Application to Modify Development Consent

**9 The Serpentine
Bilgola Beach, NSW 2107
Lot 2 DP 395158**

Rev B. REVISION B: Proposed Modification to Development Consent 2017/1343

Project: Alterations + Additions 9 The Serpentine Bilgola Beach NSW 2107	
For: Greg and Rowan Hanley

Drawing: Elevations - North, South		
Job No.: GDB-098	Lot/DP: 2 / DP 395158	Drawing No.: DA-06
First Issued: Dec 2017	Scale: 1:100 @ A3	Issue: B

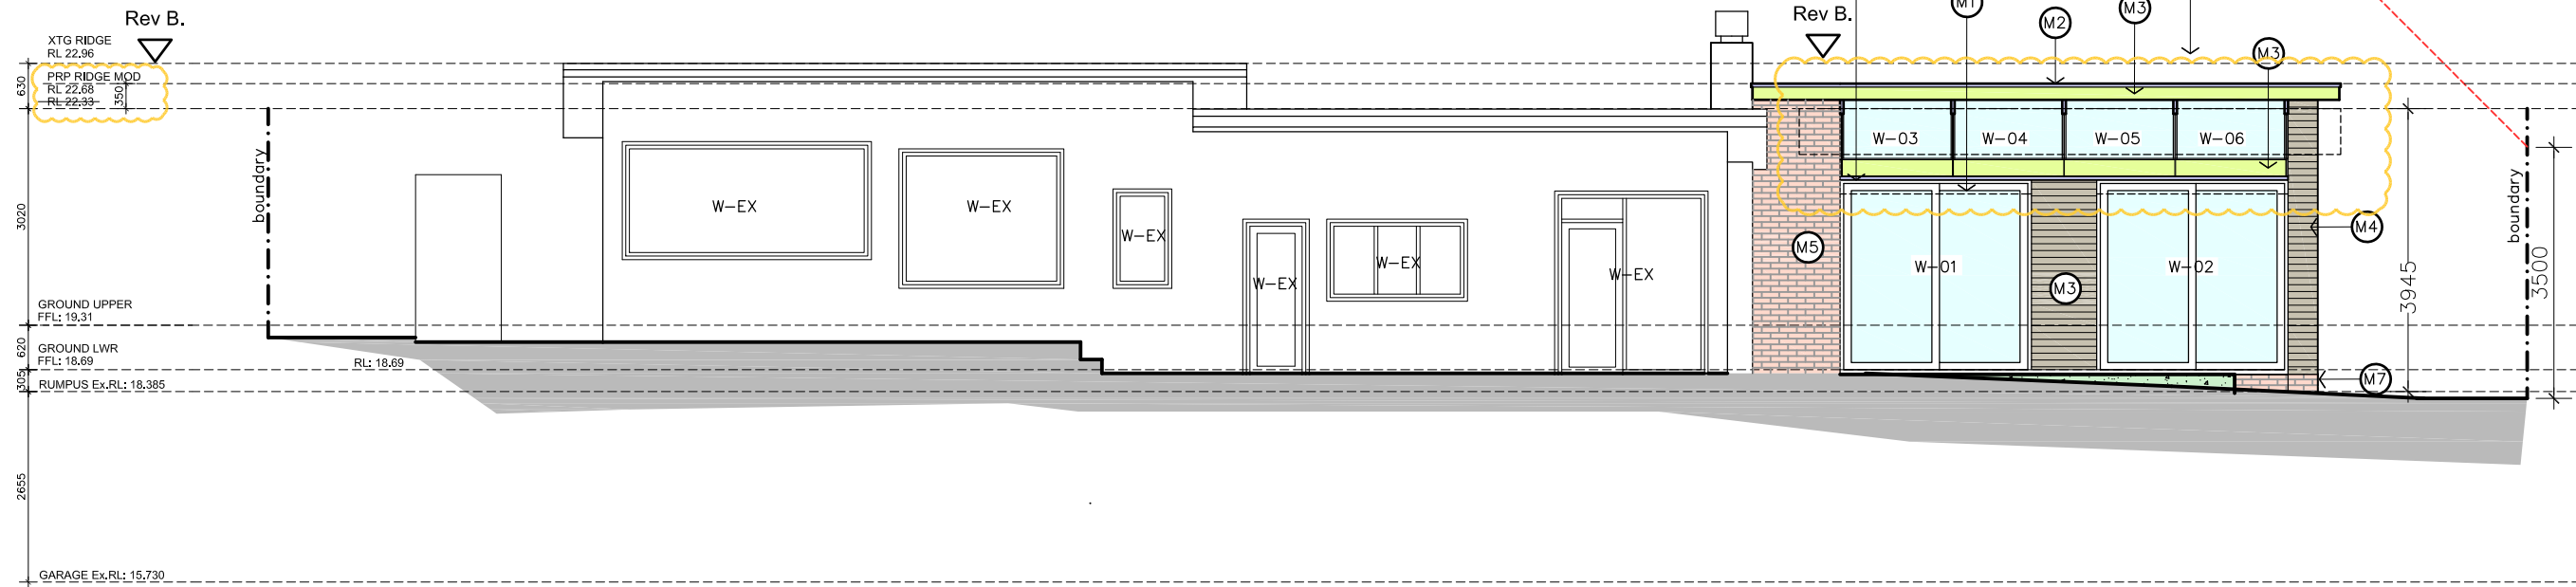
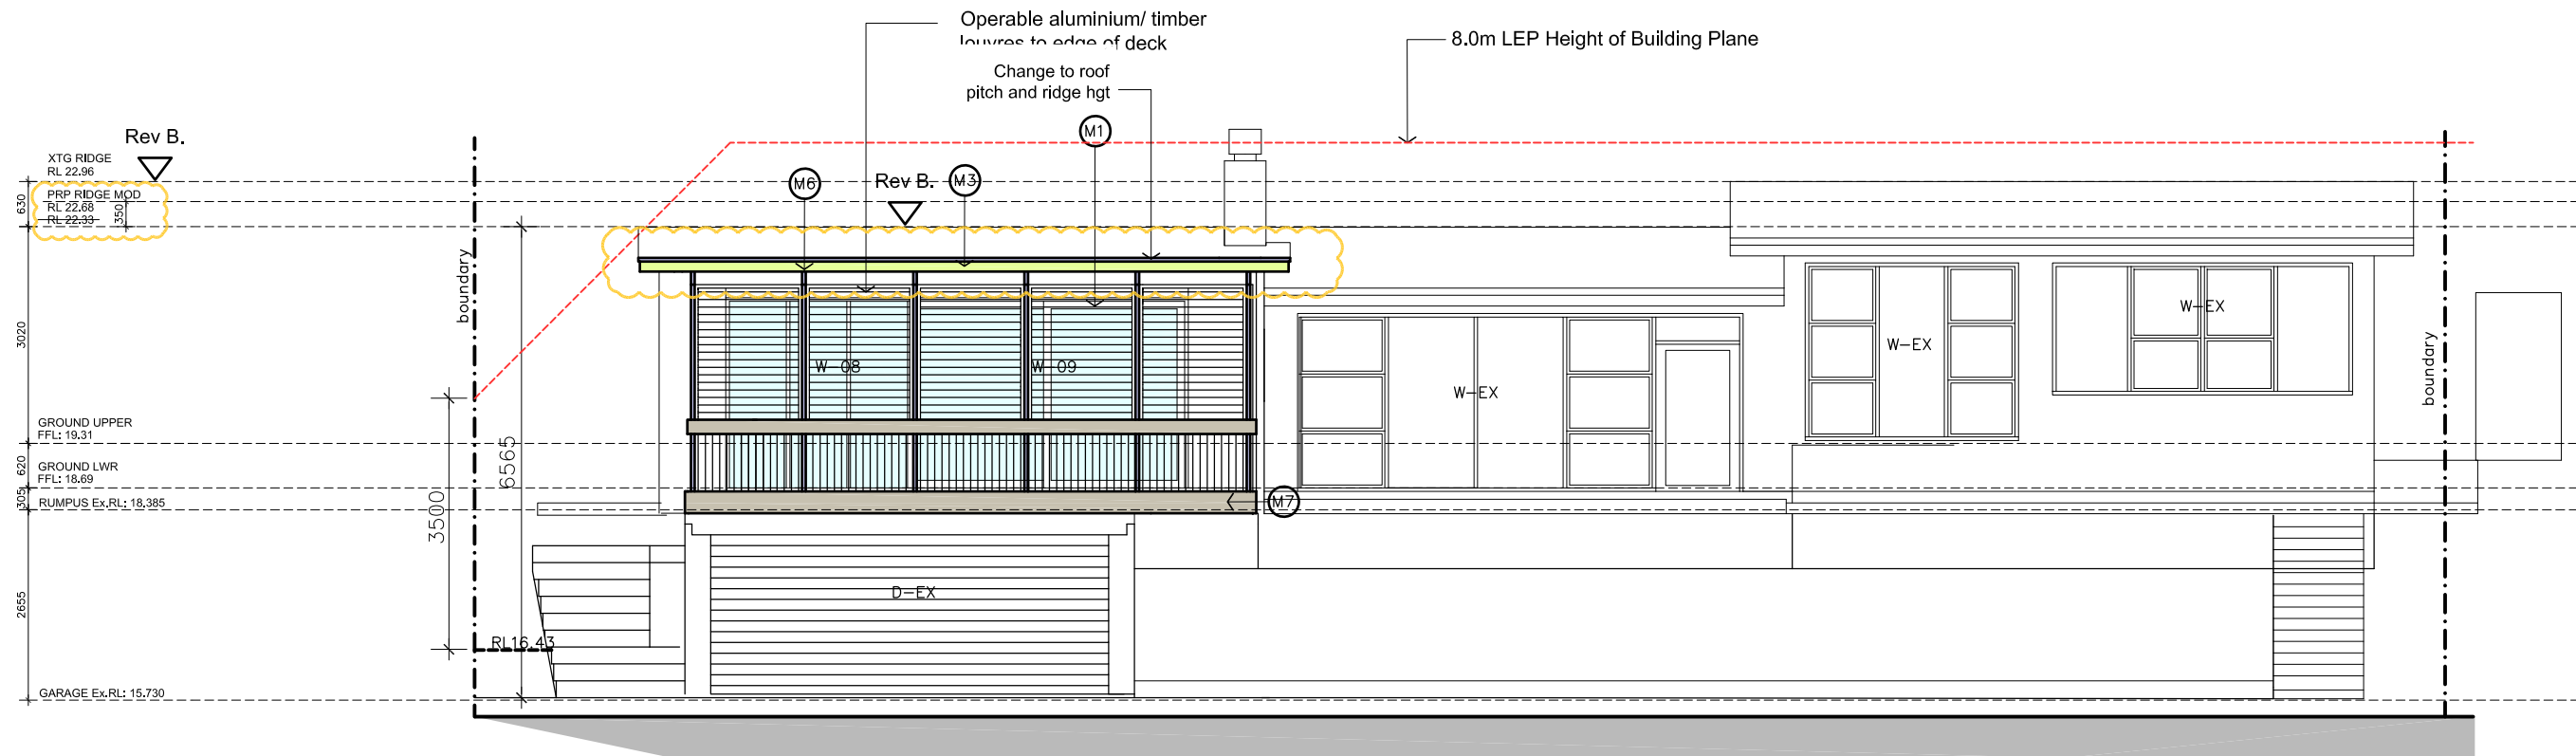
Revisions:		
Issue	Date	Amendment
Pre.01	08/12/2017	Preliminary
B	20/07/2018	Modify to dev consent. Roof pitch, W-03-W-08 hgt

Drawing: Elevations - East, West		
Job No.: GDB-098	Lot/DP: 2 / DP 395158	Drawing No.: DA-07
First Issued: Dec 2017	Scale: 1:100 @ A3	Issue: B

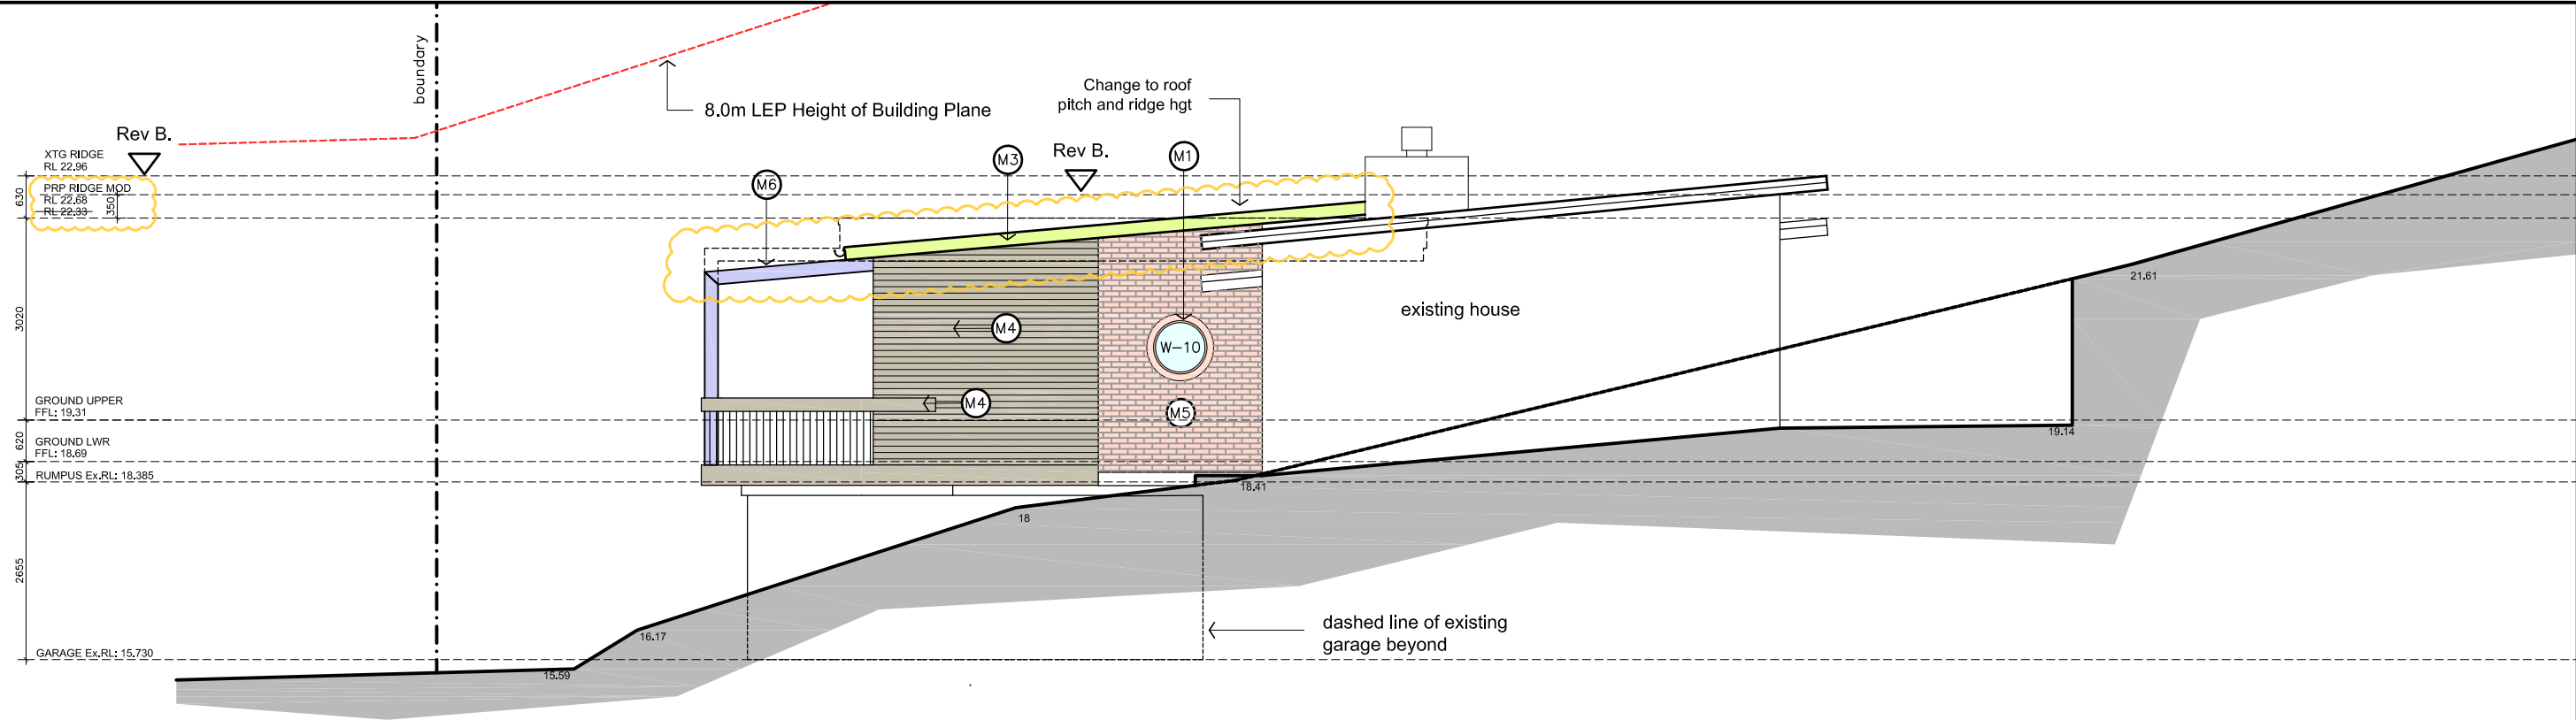
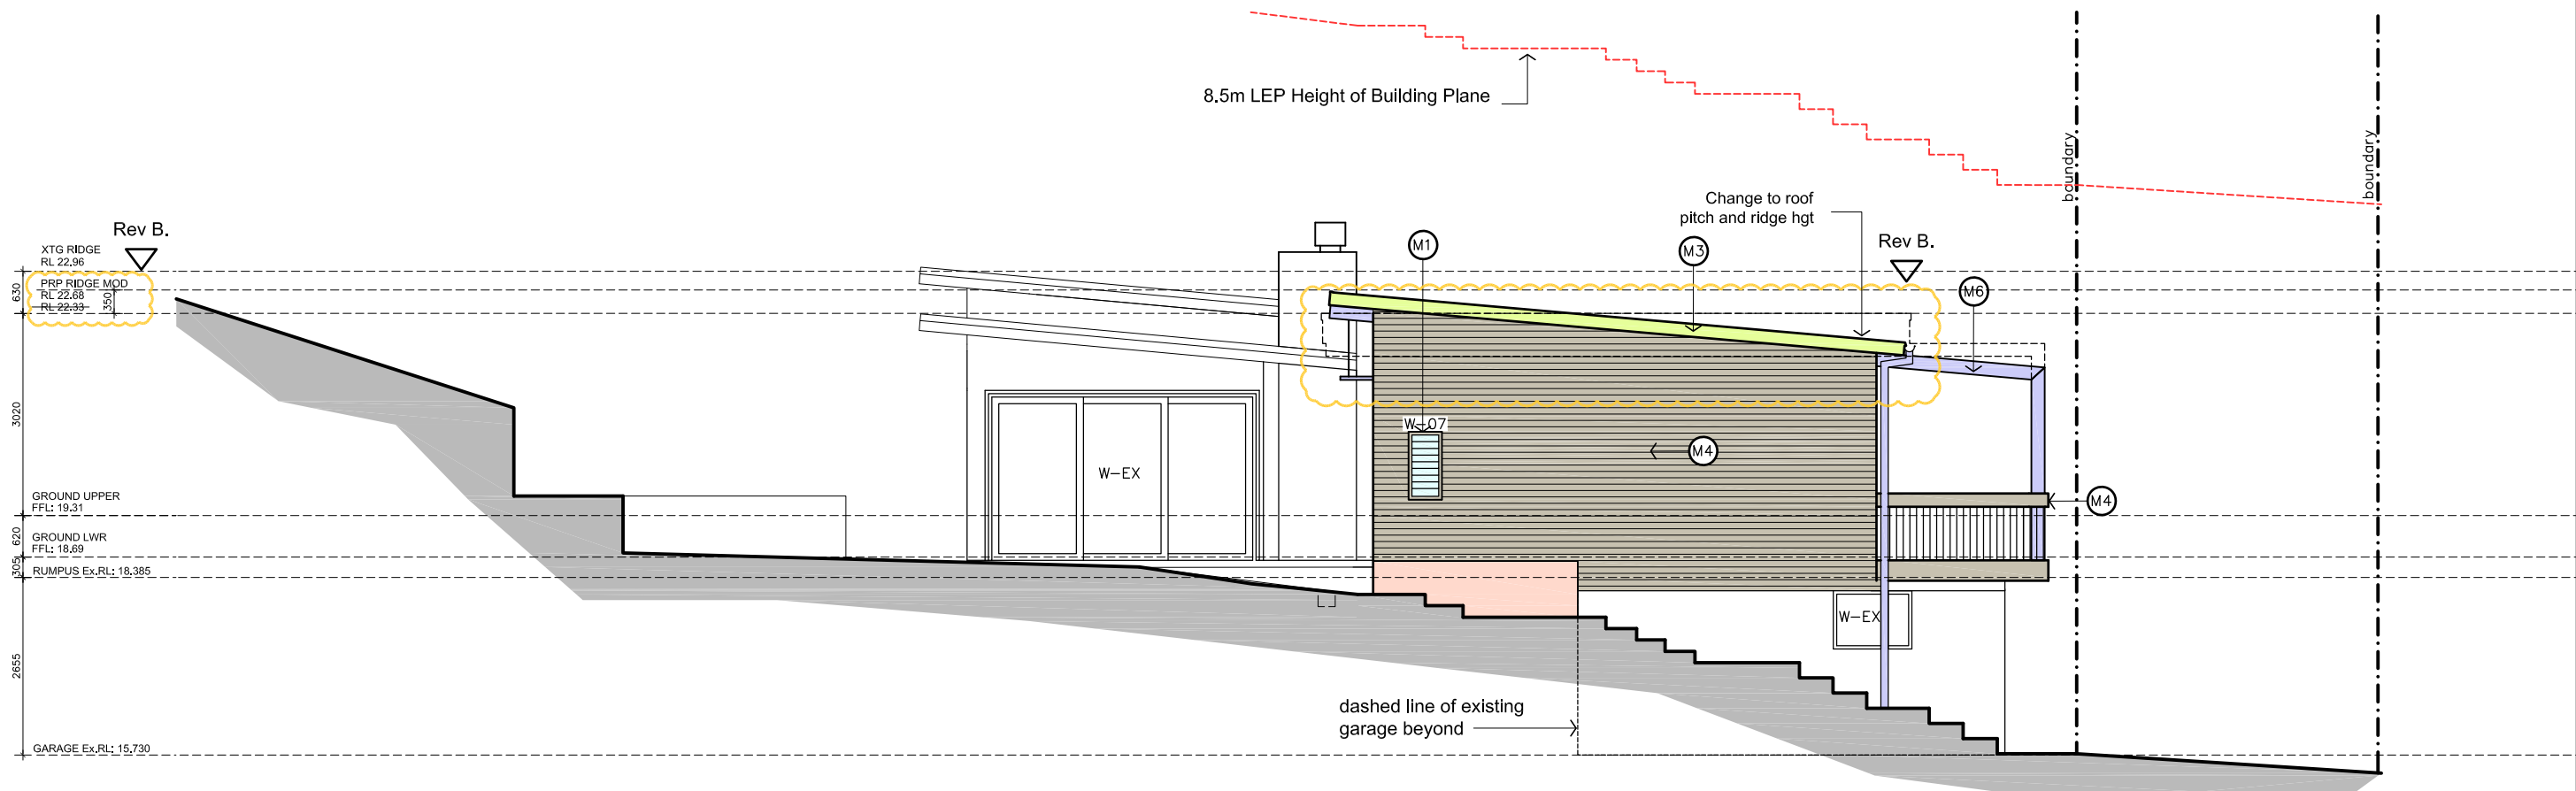
Revisions:		
Issue	Date	Amendment
Pre.01	08/12/2017	Preliminary
B	20/07/2018	Modif' to dev consent. Roof pitch, W-03-W-08 hgt
